Addendum No. 1

Project: Village on the Preserve – Phase 2
For: Lanoha Development

Date: 1 February 2012
 From: Studio 951, Ltd.
 To: All plan holders.

E2.04-3

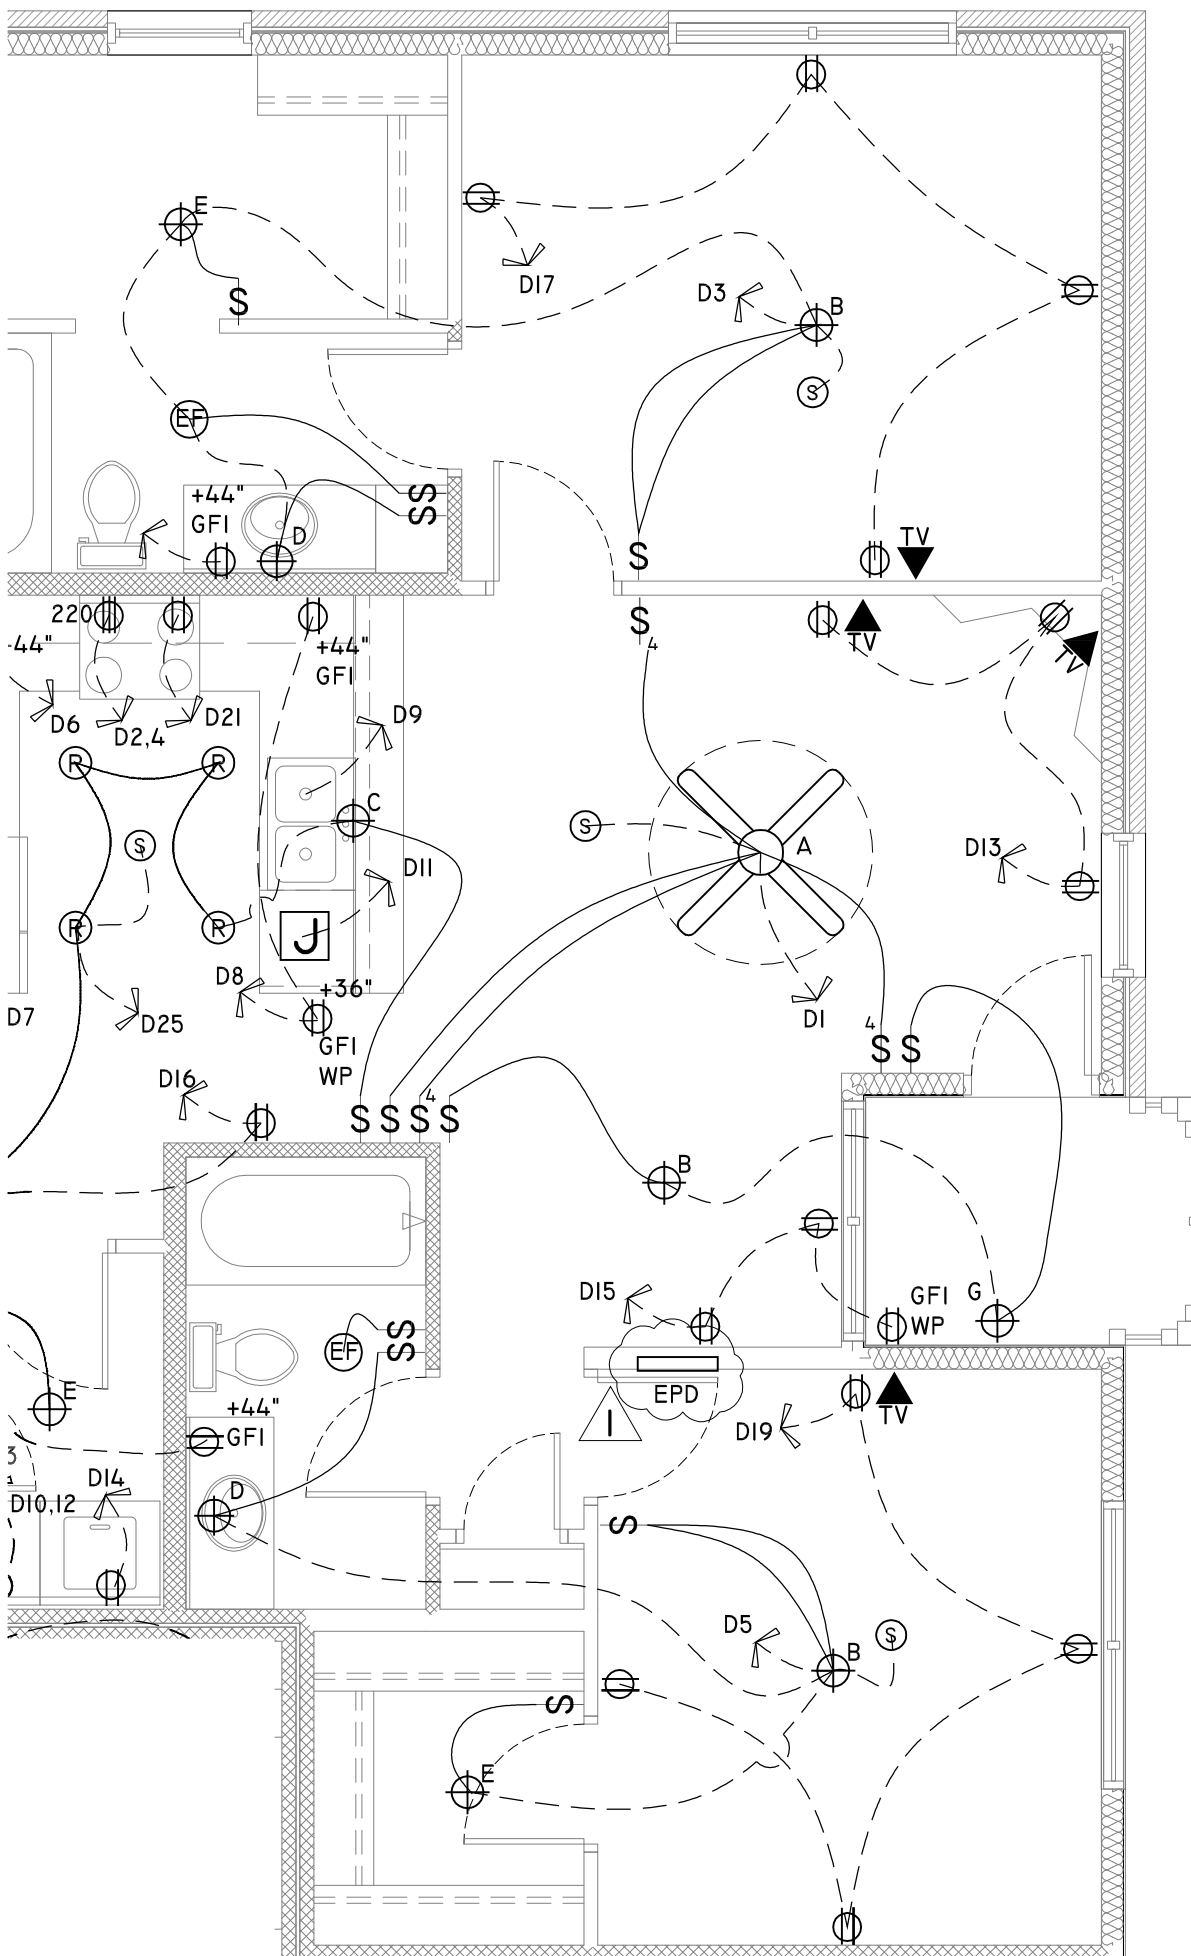
See E2.04-1, E2.04-2, E2.04-3, E2.04-4, E2.04-5, E2.04-6, E2.04-7

Please add a note to each sheet to read, "Cable TV outlet box and wiring by Others. Location shown for reference only."
